**City of Fredericksburg
Historic Review Board**

209 E San Antonio – Tequila Bar

Architectural Historical Comments Narrative (05/31/2022)

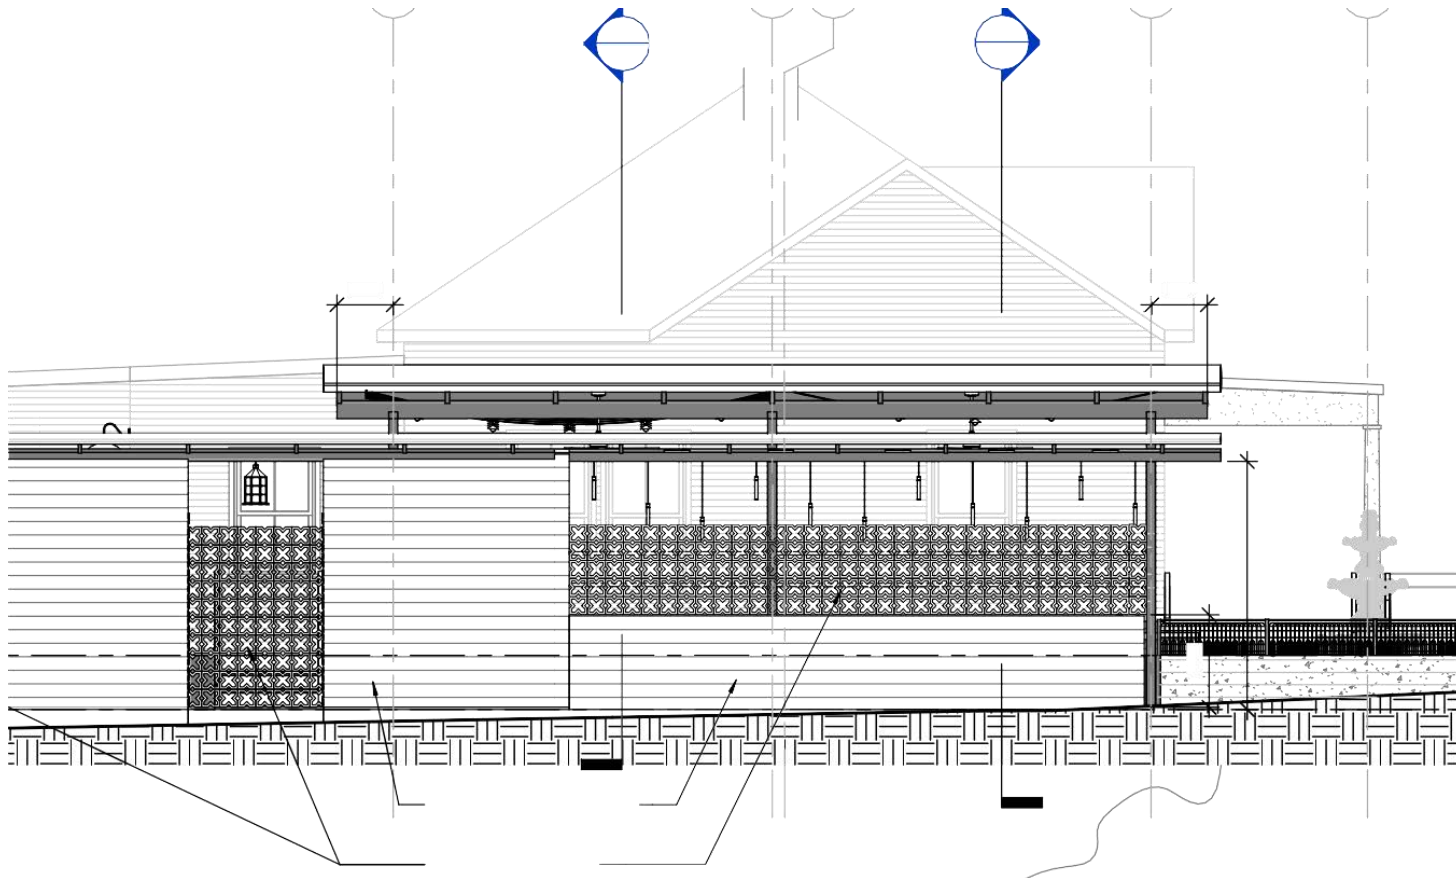
- **HRB Comment:** *“Staff recommends the new pergola/covered trellis is pulled back from the front façade. The height is compatible, and the openness of the structure is a benefit. More detail is needed on how the pergola will abut the side of the house.”*

Response: We have pulled the columns away from the existing structure by 5’-11.25” from the previous 2’0” distance which opened up the east façade of the existing structure. We removed the smaller trellised roof (the extension of the existing front porch) which also helped with the “openness” of the existing east façade of the structure. Refer to sheet A110.

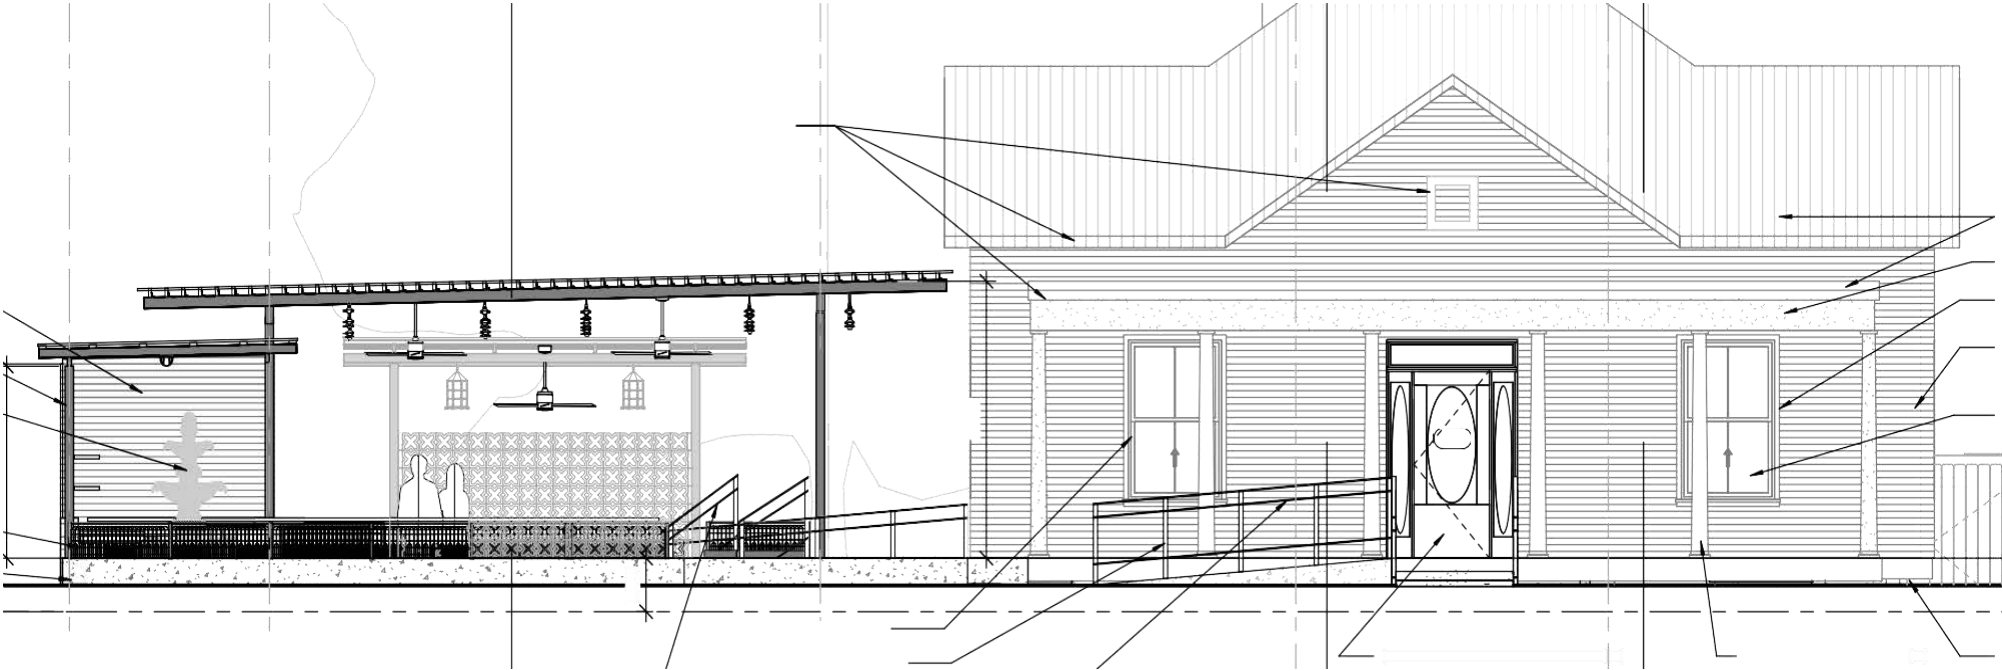
- **HRB Comment:** *For final approval more detail is needed on the proposed bar and restrooms along with lighting fixtures for the front porch and yard.*

Response: See updated Elevations on sheets A200, A201, A300, A900. Actual Light fixtures to be selected by owner. Light fixtures shown to be LED and conform with dark skies requirements.

SHEET **A200**

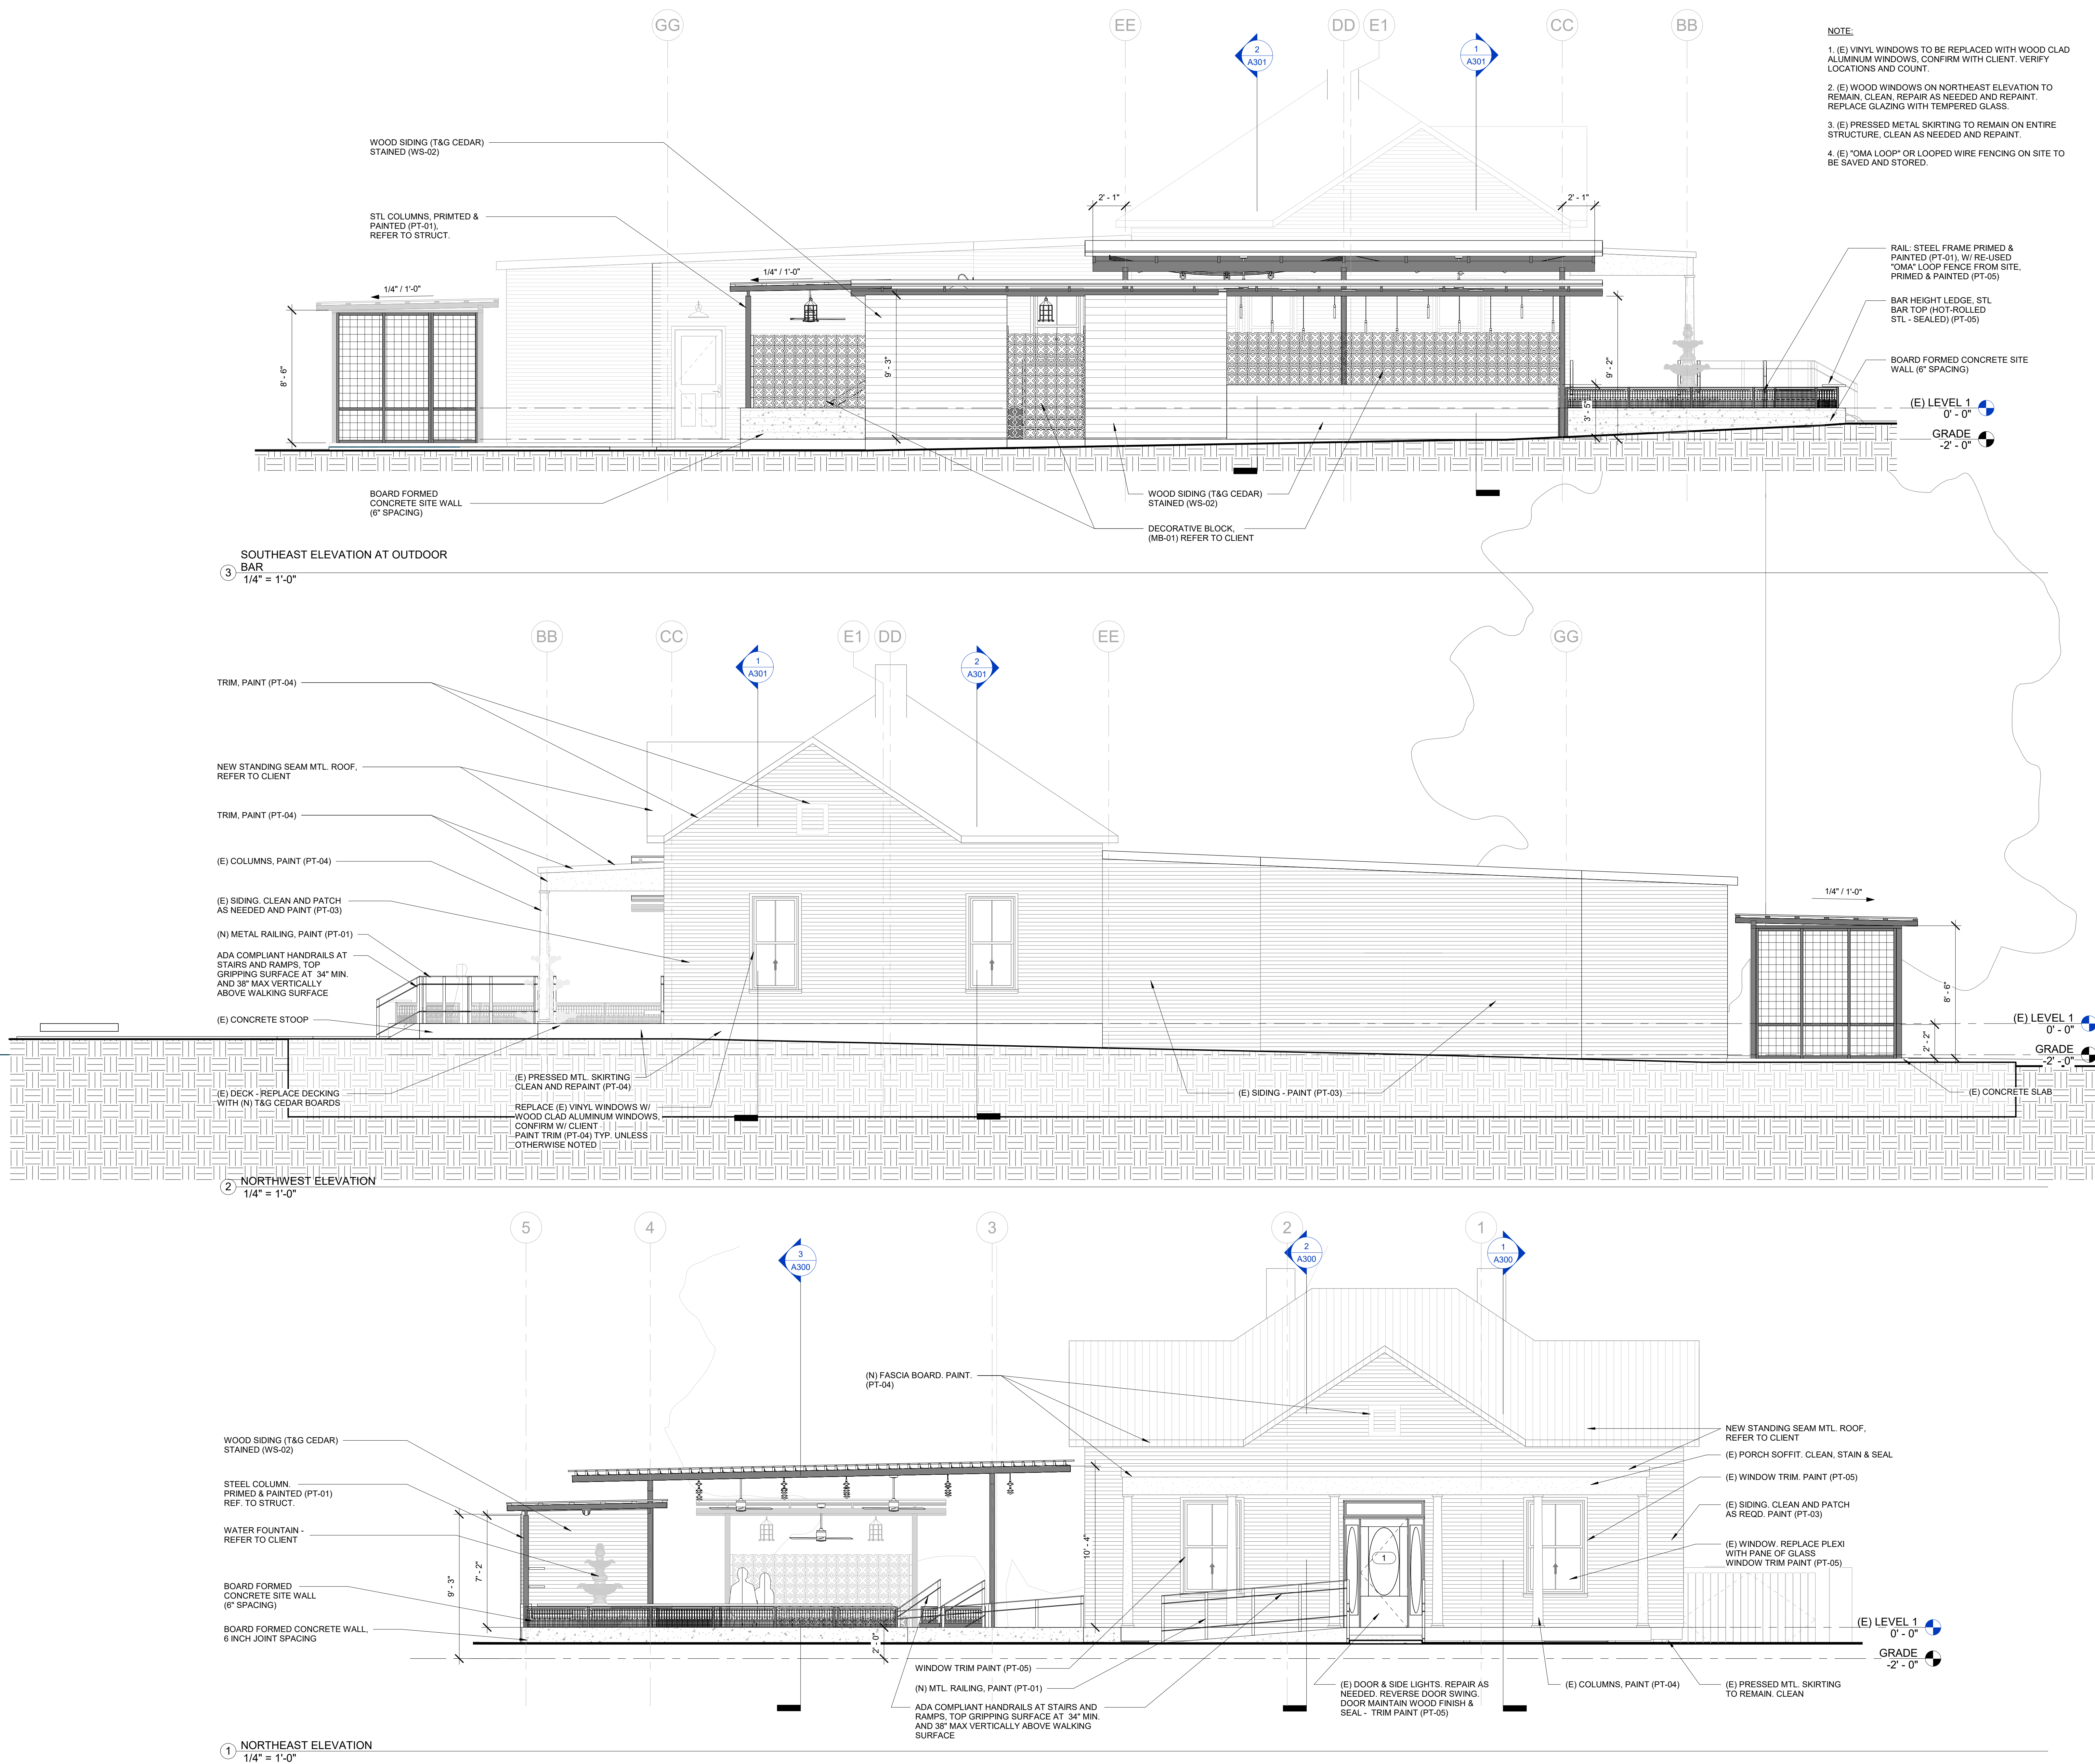
- **HRB Comment:** *“site currently has garden loop that should be kept and re-used where fencing is necessary”*

Response: We have incorporated the “garden loop” into the site perimeter fencing, refer to sheet 1/A200
